ADDENDUM #01

DATE OF ISSUE:	April 23, 2024			
PROJECT:	Twin Falls Training Facility Twin Falls, Idaho 83301	PNa PROJECT #:	19-029	
REVIEWED BY:	Tad Bradley Pivot North Architecture			
ATTACHMENTS:	Pre-BID RFI Responses 1-13			
PREVIOUS ADDENDA:	N/A

Twin Falls Fire Training Center Bidding RFI Log	APRIL 23, 2024

Panel LC

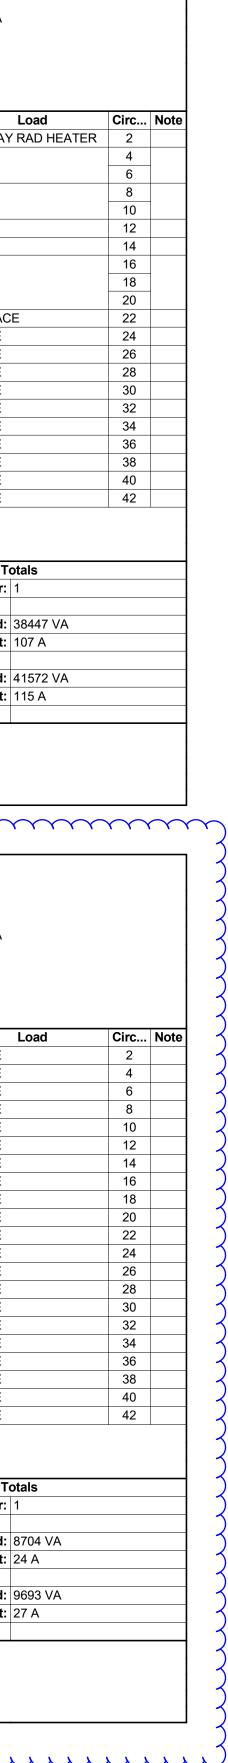
1. E4.01 Panel LC

ANSWER 4	APPROVED: 04/22/2024		
3	Panel LC	4//1/7/24	Ramseys	We need a panel schedul	le for Panel LC.	x	X
				ANSWER *	*SEE ATTACHED		_
4	Fire Alarm # 1	4/18/2024	Johnson Controls	that a graphic map annur GRAPHIC MAP ANNUNCI When a trouble, supervisi graphic map/annunciator NO. NOT REQUIRED. Along with this, I thought building will not be built of out that other section of device information for ha proceed? NOT REQUIRED. On another note, if any el project would you please	ATOR IS NOT REQUIRED. sory, alarm, or other issue is detected in the fire alarm system, is this r meant to light up an LED showing which device has detected an issue? t it to be a bit strange that they wanted a graphic map when part of the out once this project is completed. When the owner decides to build the building the map will become obsolete, only displaying correct alf the building. Can you confirm this is how the owner wants to electrical subcontractors have informed you they will be bidding on this e send their contact information to me so I can be in touch with them ypically bid to electrical contractors who carry us as the fire alarm		x

ANSWER			
5	Panel LC		Heider Electric	panel LC, its on the plans	bid together for you for this job and noticed there is not a schedule for and on the one diagram but I didn't seea detail for it. Is there a way on that one so I can make sure we include the right cost? Sent update	x	X
6	Fire Alarm Clarifications #2	4/18/2024	Johnson Controls	On the fire alarm plans fo and Horn/Strobes listed. these devices to work tog Speaker/Strobes can be p <u>HORN STROBES ARE ALL</u> Can you confirm, do you mixing with Horn/Strobes <u>HORN STROBES ARE ALL</u> Along with this, for the gr initiation devices (smokes desired? The specs do no <u>GRAPHIC ANNUNCIATOR</u>	want Speaker/Strobes throughout the whole building rather than s, or is having the Horn/Strobes necessary for the building owner? <u>THAT IS REQUIRED.</u> raphic annunciator/map, does the owner want LEDs for the fire alarm s, pulls stations, etc.) so the map annunciates or is a map without LEDs of make it clear whether LEDs are desired.		×
